**TOWN OF HERNDON, VIRGINIA
ARCHITECTURAL REVIEW BOARD WORK SESSION AGENDA
JULY 06, 2022
HERNDON MUNICIPAL CENTER
LARGE CONFERENCE ROOM, 2nd Floor
777 LYNN STREET
7:30 P.M.**

Title: ARB #22-013; New signage; 625 Elden Street

Subject: Pre-application ARB Discussion Item, DP #21-01, 555 Herndon Parkway

HERNDON, VIRGINIA

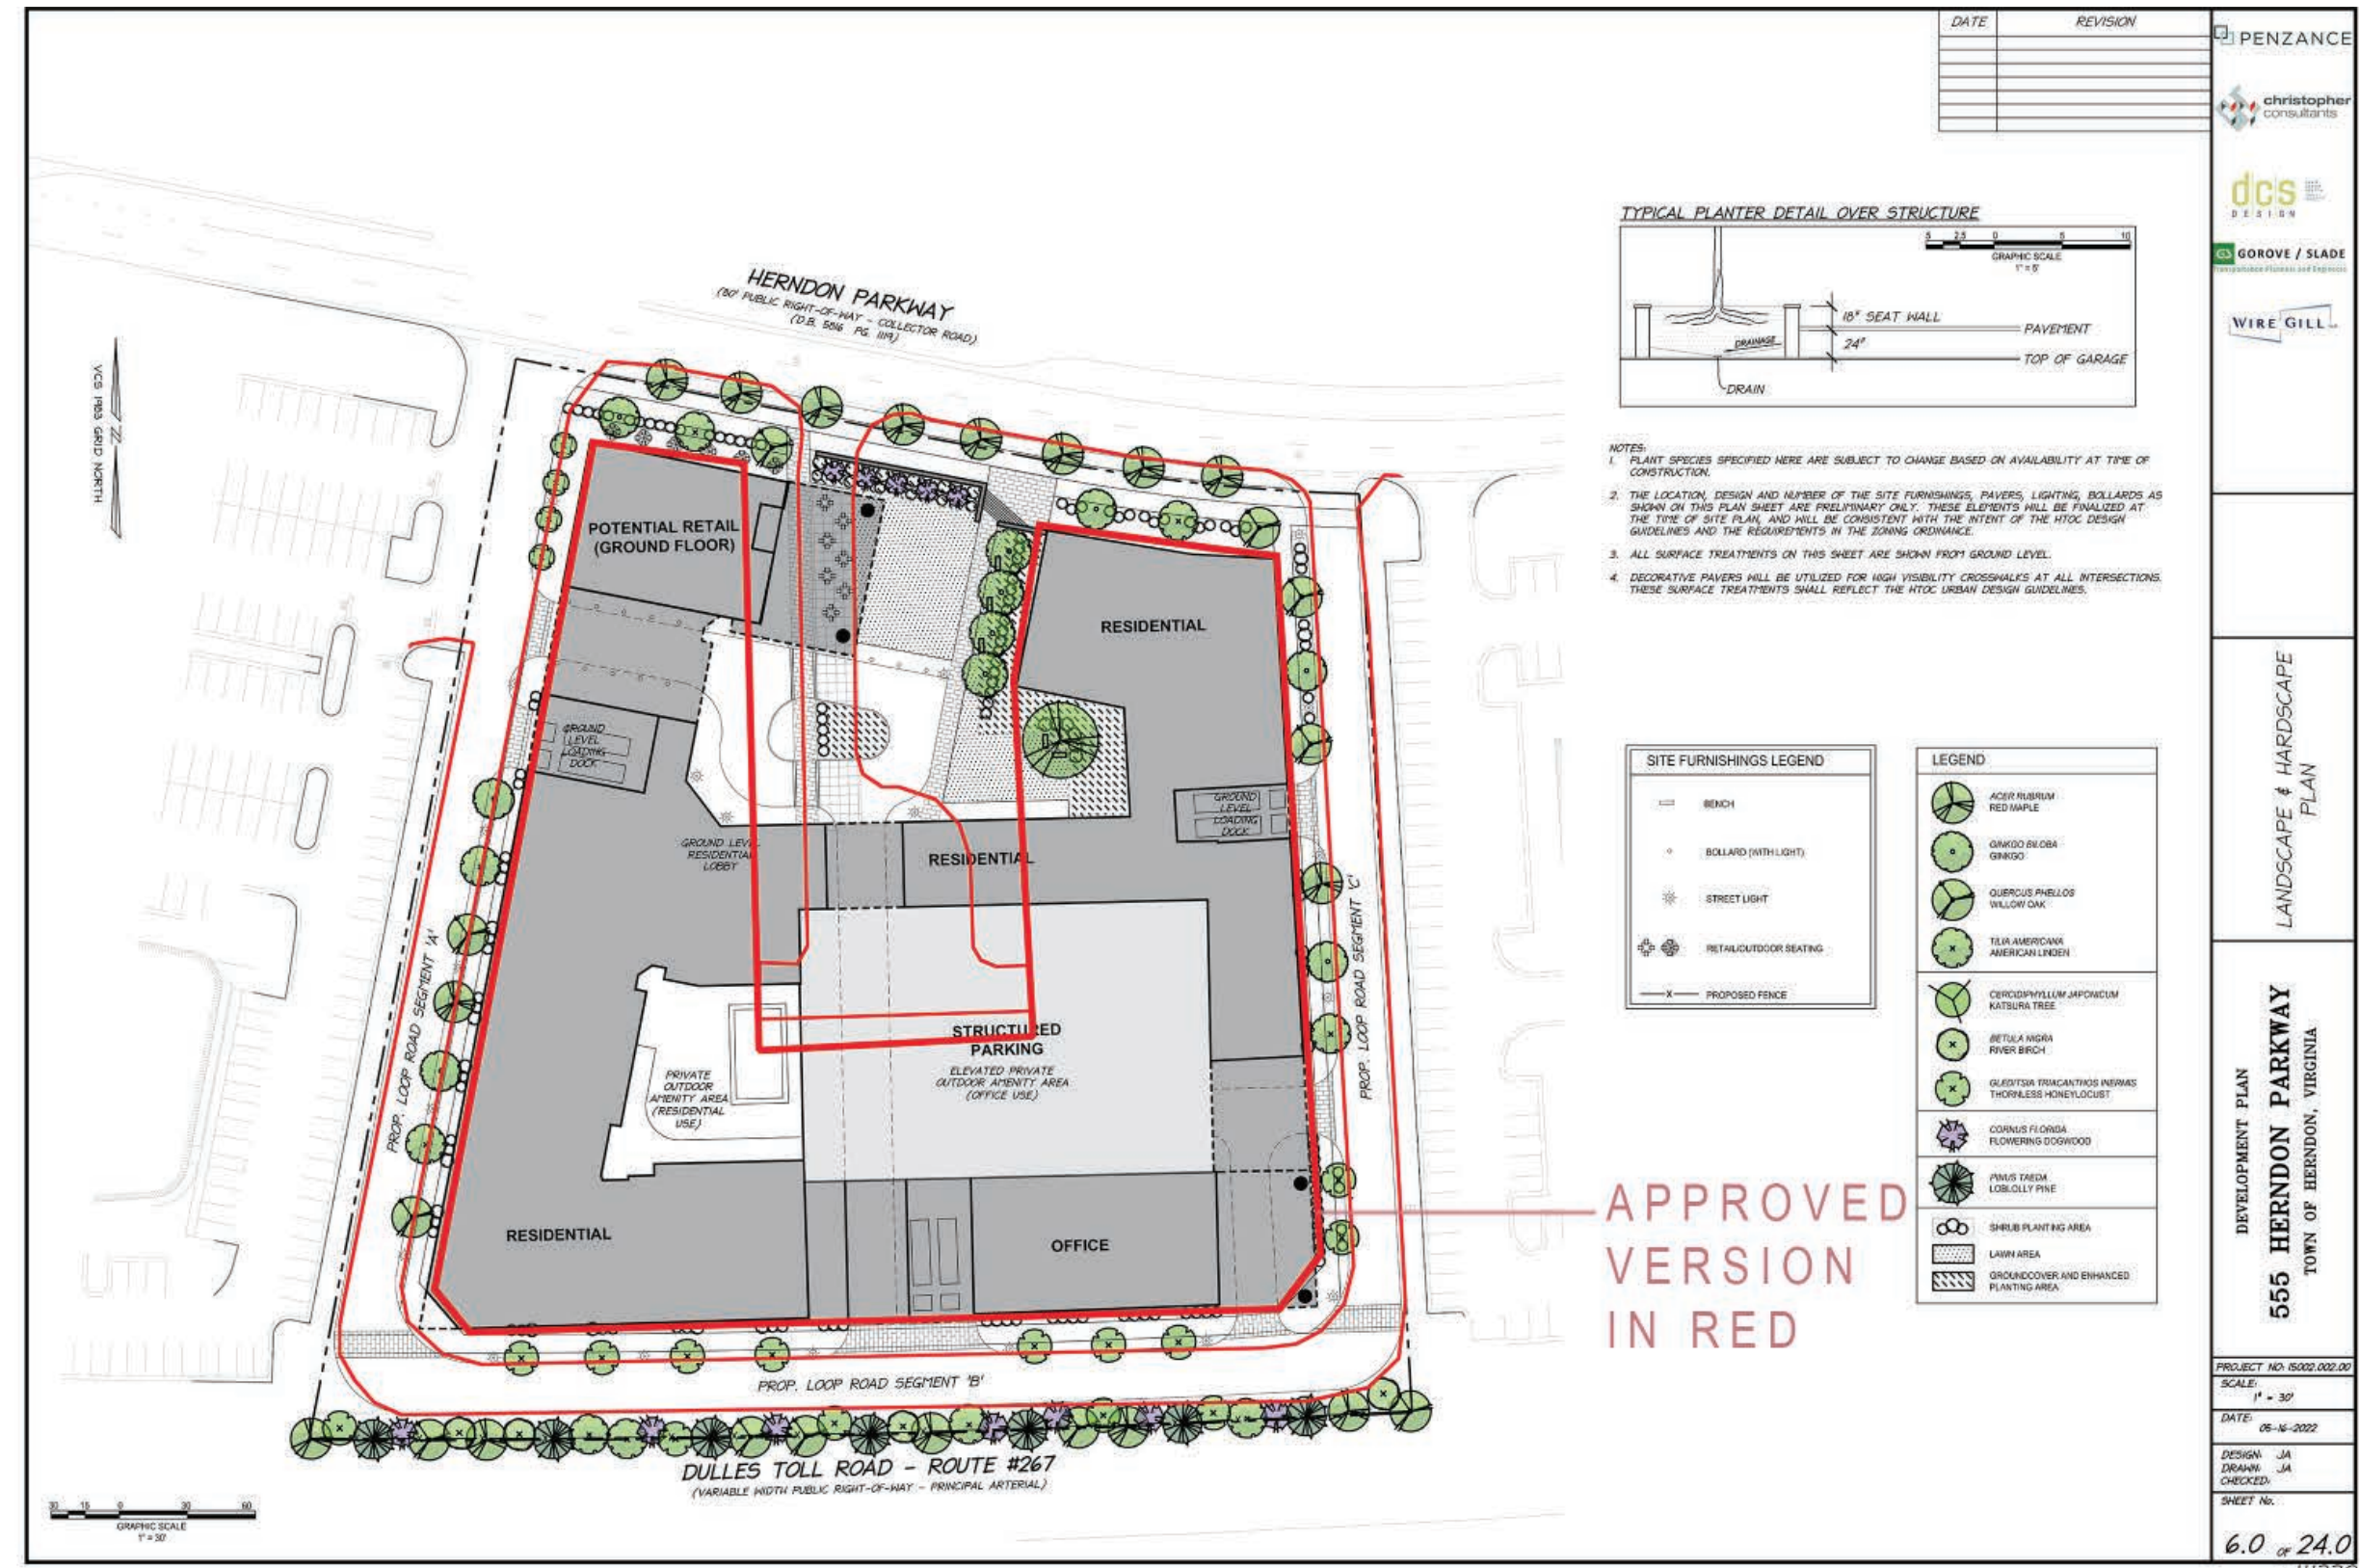
Section C of the Urban Design and Architectural Guidelines emphasizes the need for towers to have an articulated base, middle and top. As proposed, this tower does not meet that guideline. The garage access on the ground floor could be considered a base, however, it is not clearly articulated. It is difficult to review completely for the aesthetics of this portion of the design because there are limitations in the size and detail of the renderings provided. One way this is evident is that the renderings do not show how the metal mesh screening the garage portion of the tower interacts with the glazing above it. The board may wish to discuss this with the applicant. There may be a way to address the articulation of a base, middle, and top of the building using the divisions of parking and interior spaces that exist in the building already.

Staff believes that the overall design of the residential facades could be modified to more closely adhere to the guidelines by using more variation in the façade treatment. The variation that exists as proposed is minimal and color and material changes are not organized in a visually satisfactory manor but give the impression of arbitrary differentiation between areas of the façade. The Urban Design and Architectural Guidelines specify that midrise developments should be articulated to resemble an ensemble of smaller buildings. This indicates a level of order that the current design does not display. Variation in materials as proposed is important but the variation could be enhanced with a more varied color scheme and organized system of architectural divisions. Staff believes that the articulation of a cap or finish on the roofline of the residential portions may also provide needed additional articulation.
